**PPPL ENGINEERING CHANGE NOTICE (ECN) ECN # 5198**

DRAWING(S) AFFECTED NUMBER:	Current Revision	TITLE
SE121-004	0	VVSA Assembly Station 1

**ECN TITLE: Horse Collar Weldment**

**AREA OR PROJECT: NCSX**

## SECTION C-C

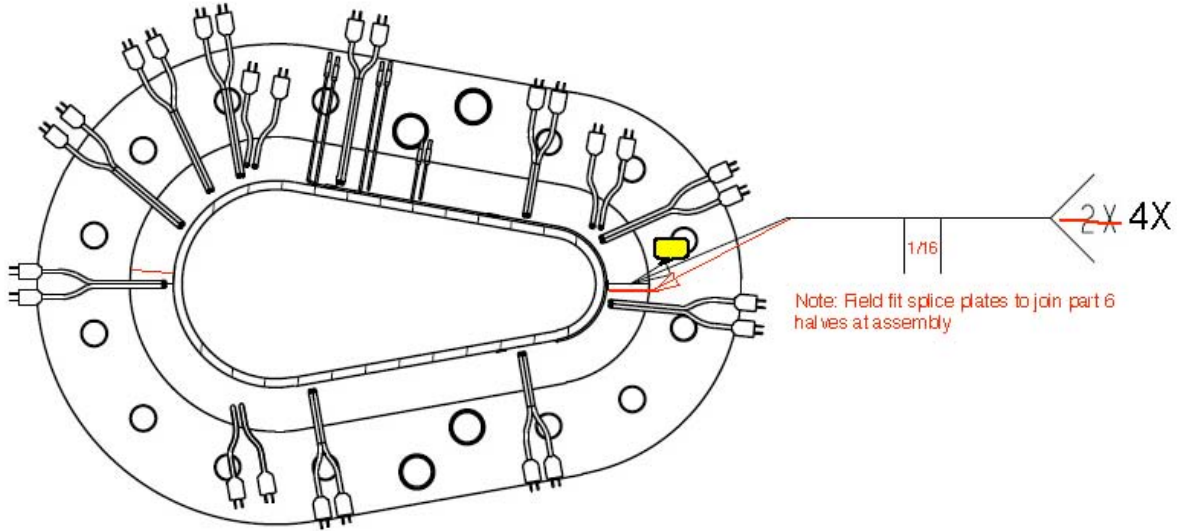
**SE121-004 (Section C-C) – add a couple of small Inconel splice plates to close the gap (~ 1/4 “).**

**Part 6 doesn't fit properly because the port 12 extensions are oversize. We can grind part 6, but that will be costly. It would be much cheaper to add a couple of small inconel splice plates to close the gap (about 1/4"). See attached sketch.**

**RLM Comments: Update drawing immediately.**
